From: Rehm, Zach@Coastal <Zach.Rehm@coastal.ca.gov>
Sent time: 02/20/2019 10:48:53 AM
To: So Kim; Selim <Selim@sawayaeng.com>
Cc: Ara Mihranian; Jill Martin <jmartin@trumpnational.com>
Subject: RE: Tract 50666 Fencing plan

From: Selim [<mailto:Selim@sawayaeng.com>]
Sent: Monday, August 27, 2018 7:45 AM
To: So Kim <SoK@rpvca.gov>; 'Rehm, Zach@Coastal' <Zach.Rehm@coastal.ca.gov>
Cc: 'Jill Martin' <jmartin@trumpnational.com>
Subject: Tract 50666 Fencing plan

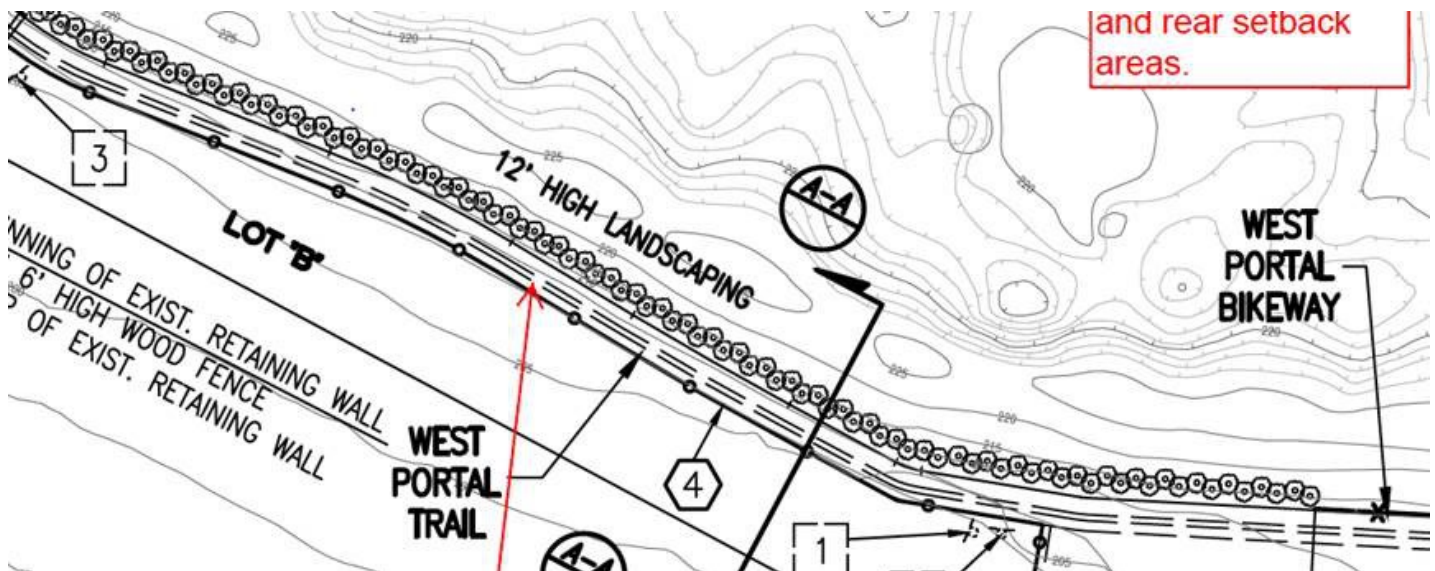
- 3) Based on Mitigation Measure H-1 above, remove the 6' tall fence located in the bubbled area since there is already a hedge there and begin the fence from the south end of the west hedge to the west end of the south hedge as shown in the solid red line below. Please change the notation from "6' HIGH LATTICE" to "LATTICE FENCE NOT TO EXCEED 6' IN HEIGHT OR THE RIDGE ELEVATION OF THE SOUTHERLY BERM". I understand that by doing so, there may be a gap between the west hedge and the new fence.

Hi So and Selim, the requested clarifications to the notes are consistent with the Coastal Commission approved CDP.
